UNITED STATES PATENT AND TRADEMARK OFFICE

APPLICATION NO.	FILING DATE	FIRST NAMED INVENTOR	ATTORNEY DOCKET NO.	CONFIRMATION NO.
09/872,319	06/01/2001	Lennart Axelsson	LCB 363	4554

Office Action Summary

DETAILED ACTION

Fig. 1

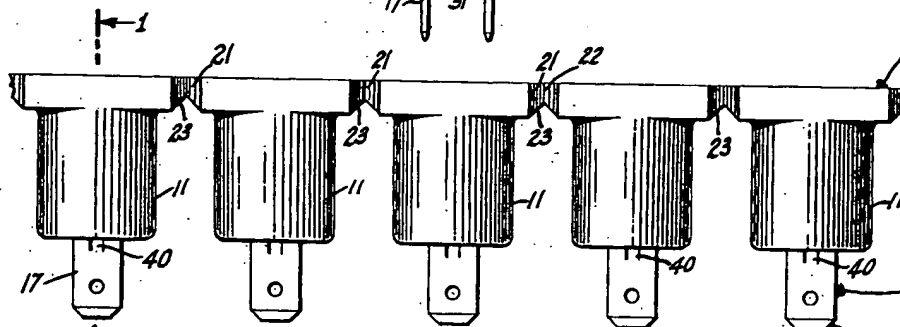
5. Claims 1-6 are rejected under 35 U.S.C. 102(b) as being anticipated by Clarkson et al. (U.S. Patent No. 3,082,397). With regard to Claim 1, Clarkson et al. discloses a terminal (Fig. 1) disposed on a carrier strip (Fig. 2), the terminal (Fig. 1) comprising: a contact portion (tip portion of 13 and 15); and a generally round barrel portion (11) attached to the carrier strip (Fig. 2), the barrel portion (11) having a generally squared shoulder (Attachment 1) where the barrel portion (11) meets the carrier strip (Fig. 2), the squared shoulder (Attachment 1) facilitating cutting the terminal (Fig. 1) completely from the carrier strip (Fig. 2). See Figs. 1-6 and Attachment 1.

With regard to Claim 2, Clarkson et al. discloses the round barrel portion (11) of the terminal (Fig. 1) being attached to the carrier strip (Fig. 2) at two distinct points and

the generally round barrel portion (11) has a generally squared shoulder (Attachment 1) at each of the distinct points. See Figs. 1-6 and Attachment 1.

With regard to Claim 3, Clarkson et al. discloses the terminal (Fig. 1) further comprising an intermediate portion (Attachment 1) disposed between the contact portion (tip portion of 13 and 15) and the barrel portion (11). See Figs. 1-6 and Attachment 1.

With regard to Claim 4, Clarkson et al. discloses a carrier strip (Fig. 2) integrally connecting and including a plurality of terminals (Fig. 1), each of the plurality of terminals (Fig. 1) comprising a contact portion (tip portion of 13 and 15) and a generally round barrel portion (11) attached to the carrier strip (Fig. 2), the barrel portion (11) having a generally squared shoulder (Attachment 1) where the barrel portion (11) meets the carrier strip (Fig. 2), the squared shoulder (Attachment 1) facilitating the complete removal of the terminals (Fig. 1) from the carrier strip (Fig. 2). See Figs. 1-6 and Attachment 1.

With regard to Claim 5, Clarkson et al. discloses each of the plurality of terminals (Fig. 1) further comprising an intermediate portion (Attachment 1) disposed between the contact portion (tip portion of 13 and 15) and the barrel portion (11). See Figs. 1-6 and Attachment 1.

With regard to Claim 6, Clarkson et al. discloses the plurality of terminals (Fig. 1) being integrally connected with links of the carrier strip (Fig. 2) and the terminals (Fig. 1) are arranged on the carrier strip (Fig. 2) such that there are first and last end terminals (Fig. 1) with a plurality of intermediate terminals (Fig. 1) disposed between the end

terminals (Fig. 1) on the carrier strip (Fig. 2), wherein each of the end terminals (Fig. 1) includes a barrel portion (11) having a single generally squared shoulder (Attachment 1) where the barrel portion (11) meets one of the links of the carrier strip (Fig. 2) and each of the intermediate terminals (Fig. 1) includes a barrel portion (11) having a pair of generally squared shoulder (Attachment 1) generally diametrically opposed on the barrel portion (11) such that each shoulder (Attachment 1) meets one of the links of the carrier strip (Fig. 2). See Figs. 1-6 and Attachment 1.
